**PARK CITY MUNICIPAL CORPORATION
PLANNING DEPARTMENT ADMINISTRATIVE PUBLIC HEARING MINUTES
PLANNING DEPARTMENT CONFERENCE ROOM
MARSAC MUNICIPAL BUILDING
APRIL 2, 2026**

B. 322 Main Street – Historic District Design Review – The Applicant Proposes a Rooftop and Rear Addition to a Landmark Historic Structure in the Historic Commercial Business Zoning District. PL-24-06265.

Figure 1: Excerpt from Applicant's plans showing the maximum Building volume highlighted in orange and the proposed Building volume.

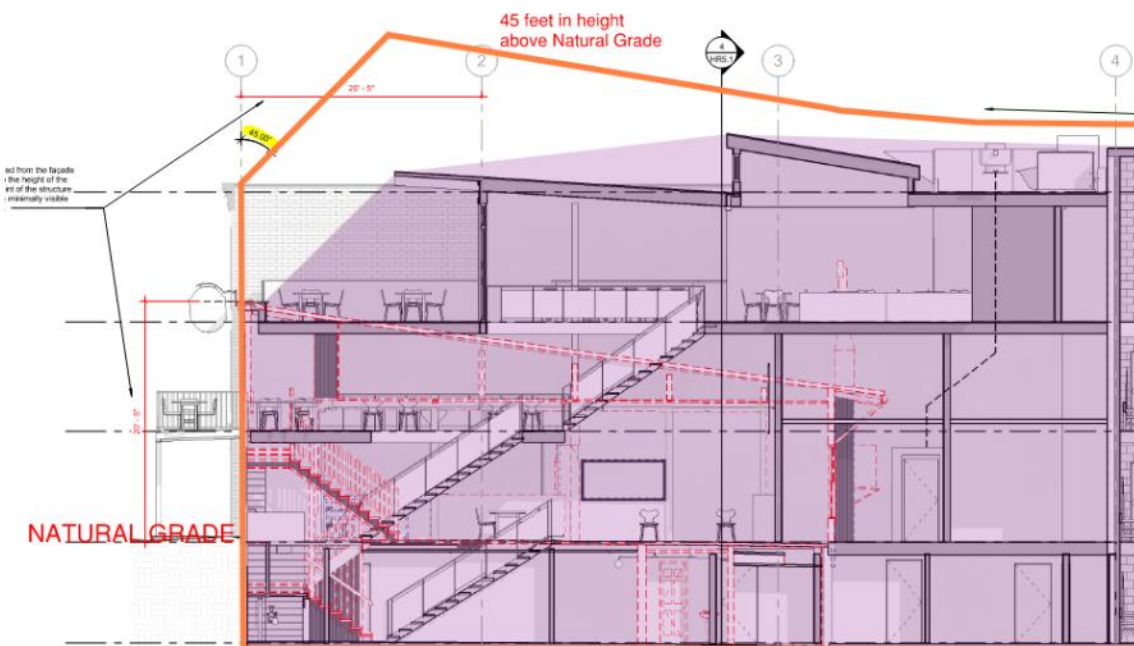
Pursuant to LMC § 15-2.6-5(A), “[t]he maximum Building volume for each Lot in the HCB Zoning District is defined by a plane that rises vertically at the Front Lot Line to a height of 30 feet measured above the average Natural Grade, proceeding at a 45-degree angle toward the rear of the Property until it intersects with a point 45 feet above the Natural Grade and connects with the rear portion of the bulk plane.”

The front plane of the Landmark Historic Structure rises 20 feet 5 inches above the average Natural Grade and then proceeds at a 45° angle toward the rear of the Property. The roof-top addition and the rear addition are within the maximum Building volume.

Figure 2: Excerpt from Applicant's plans with staff's markup showing the maximum Building volume outlined in orange and the proposed rear addition building volume.

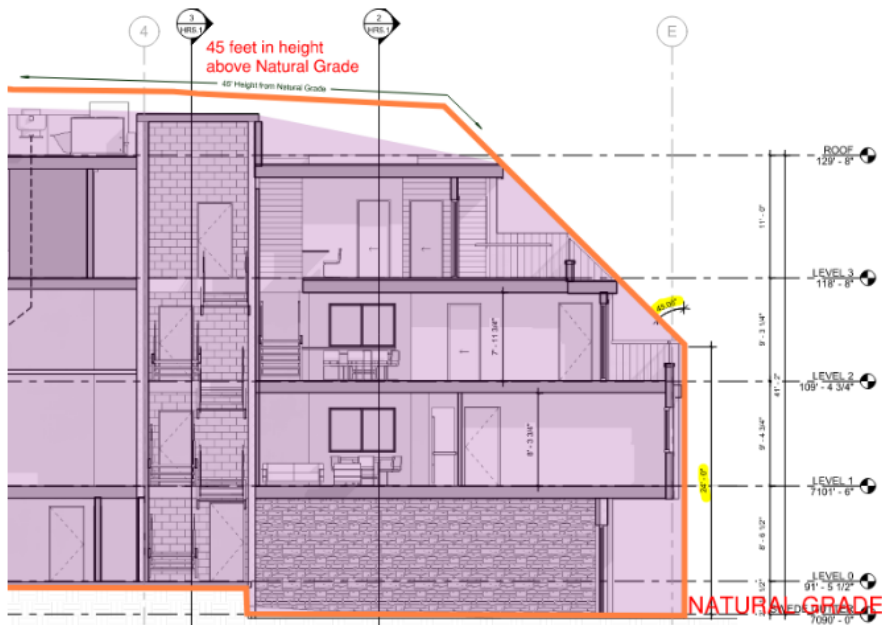
Pursuant to LMC § 15-2.6-5(C), “for Lots abutting Swede Alley, the rear portion of the bulk plane is defined by a plane that rises vertically at the Rear Property Line to a height of twenty-four feet (24’) measured above the average Natural Grade and then proceeds at a forty-five degree (45°) angle toward the Front Lot Line until it intersects with a point forty-five feet (45’) above the Natural Grade. This provision must not be construed to encourage solid roofing to follow the forty-five degree (45°) back plane.”

The rear portion of the bulk plane rises vertically at the Rear Property Line to a height of 24 feet measured above the average Natural Grade and then proceeds at a 45-degree angle toward the Front Lot Line until it intersects with a point 45 feet above the Natural Grade and complies. The rear roof is not solid; it steps back in three intervals at a 45-degree angle.

Figure 3: Table provided by Applicant listing Net Livable square footages for each space and the total floor Area

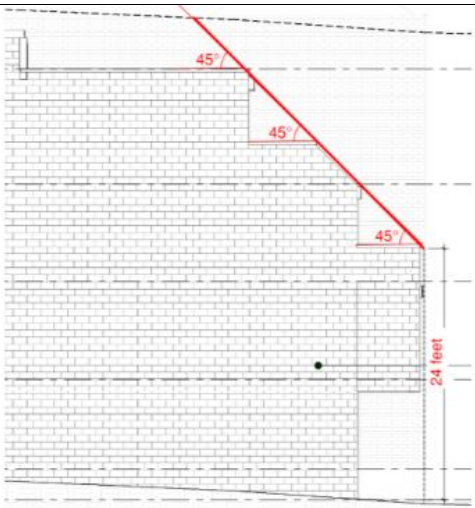
Pursuant to LMC § 15-2.6-6, “[t]o encourage variety in Building Height, a floor Area to ground Area ratio must be used to calculate maximum buildable Area. The maximum Floor Area Ratio (FAR) is 4.0 measured as: total floor Area divided by Lot Area equals 4.0.”

The Lot Area of 322 Main Street is 3,131 square feet and the total floor Area of the existing Historic Structure and proposed roof-top addition and rear addition is 9,149 square feet, as indicated in the Applicant’s plans. The total floor Area of 9,149 square feet divided by the total Lot Area of 3,131 square feet results in a FAR of 2.92 and complies.
